TECHNICAL BULLETIN

CABIN DOOR MODIFICATION

All MD900 helicopters.

9B52-185

Figure 1. Cabin Door Modification

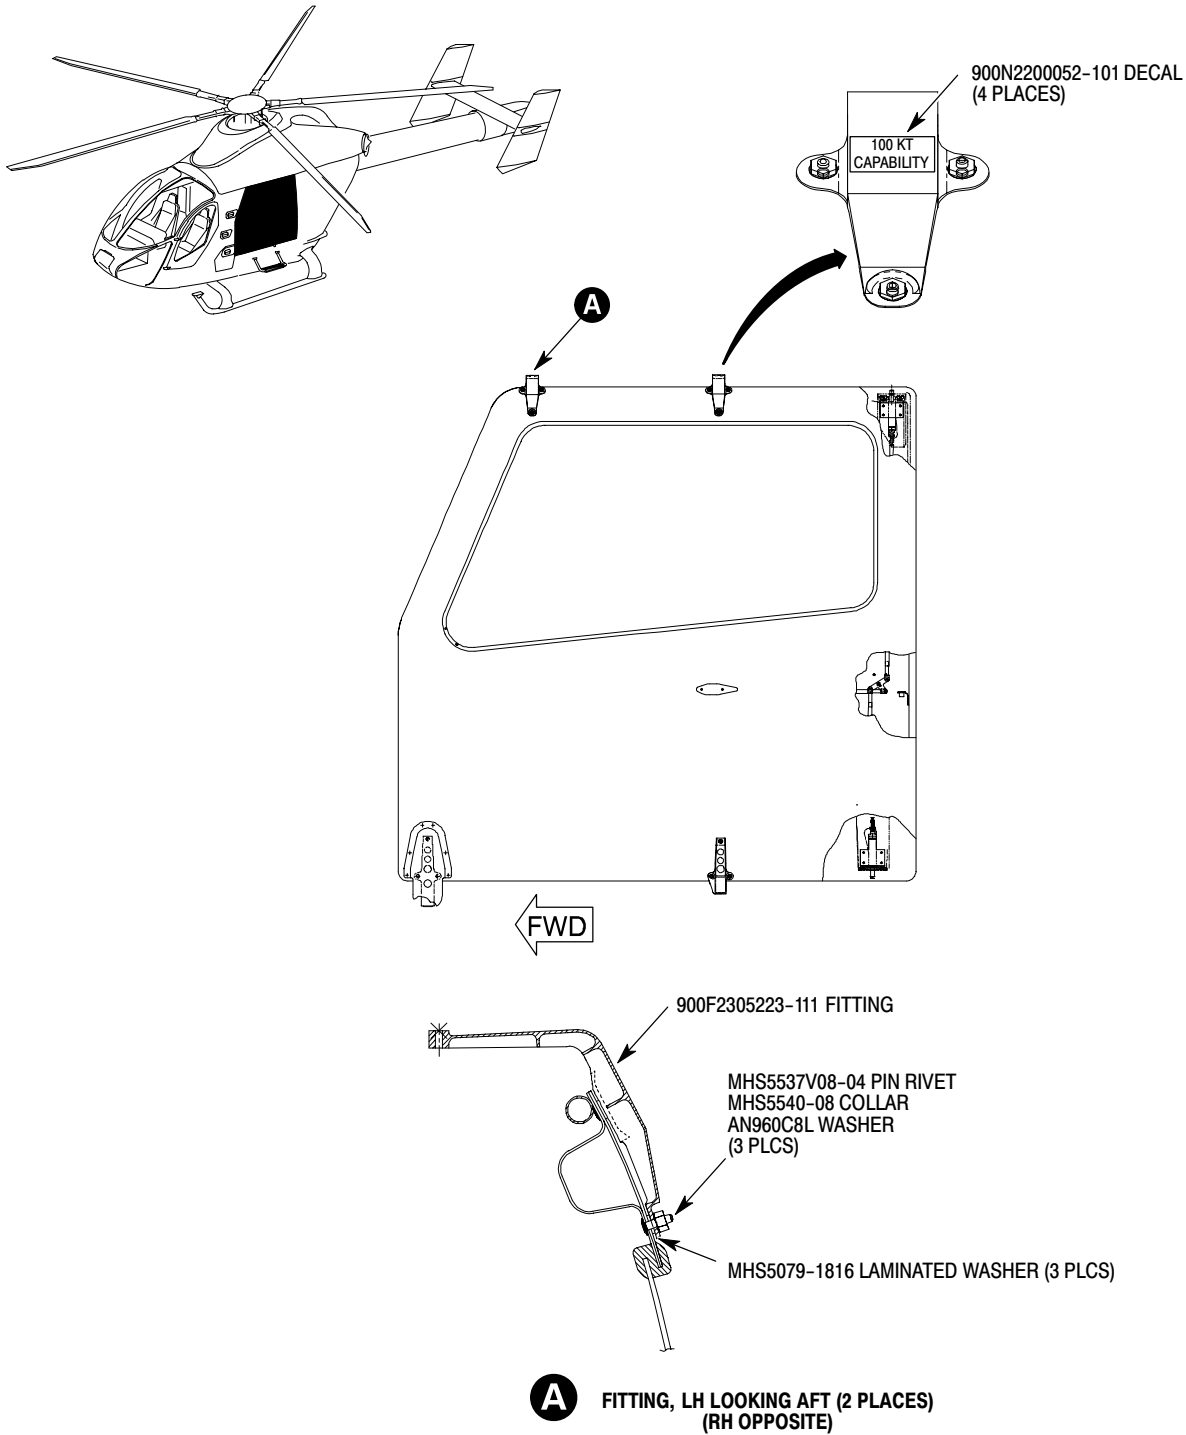
Procedures in this Bulletin provide owners and operators with information pertaining to modification of the LH and RH cabin doors to install strengthened upper fittings.

- (4). Install new upper fittings on cabin doors using new pin rivets and collars and retained washers and laminated washers. Install pin rivets in forward fittings wet with conductive sealant.

- (7). Install retained components on upper door fittings (Ref. CSP-900RMM-2, Section 52-00-00, Door Upper Fitting Components Installation).
- (8). Install 100 kt Capability decals.

- (a). Install one decal on each upper door fitting using epoxy cement per manufacturer's instructions.
 - (b). Apply clear epoxy to placard per manufacturer's instructions.
